No. 91. 6. 017/B

Saab Safir 91B, 91B-2, 91C and 91D

SUBJECT: Exchange of sealings in auxiliary fuel pump with filter SA-1076238.

Availability of an improved type of clamps for the filter bowls.

Figure 1

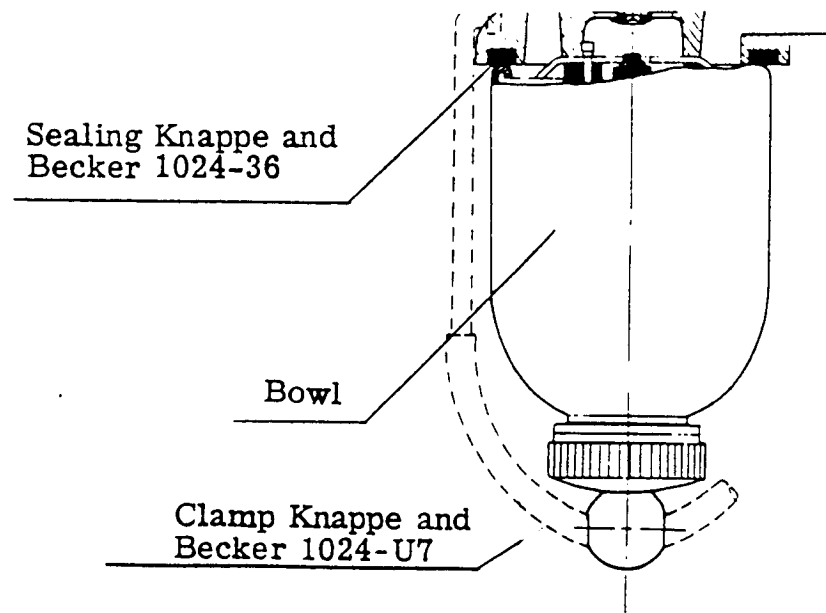
REASON: When replacing the filter bowls after draining of the fuel filters it may happen that the bowls do not seal against the pump body.

The reason is that the rubber sealings in the previous material (Dichtring 1024-36 according to spare parts list 1024 B of Knappe and Becker) between the bowls and the pump body are permanently deformed of the sealing edges of the bowls.

The leaking can cause air to enter the fuel system causing low and flickering fuel pressure.

Sealings of type 1024-36, see figure 1, shall be exchanged for new ones of better quality as soon as possible, either made by SAAB, P/N 1155687, or made by the pump manufacturer Knappe and Becker, PN 1024-36. Knappe and Becker has not changed the part number, but all future deliveries will be of the improved quality.

Note: Old stock of sealing 1024-36 should be scrapped.

After fitting new sealings, a green dot should be painted on the pump housing near the numbering plate.

a. That the sealings will fit properly in the grooves of the pump body and are not permanently deformed (of the sealing edges of the filter bowls). In this case exchange the sealings for new ones.

b. That the filter bowl is not deformed (elliptic) and that the sealing edge is flat, smooth and well rounded.

- c. When replacing the bowl check that it will rest perfectly in the groove in the pump body and that it will seal without excessive tightening of the retaining knob. Check also that there is sufficient clearance between the filter bowl and the clamp. Do not overtighten the clamps.
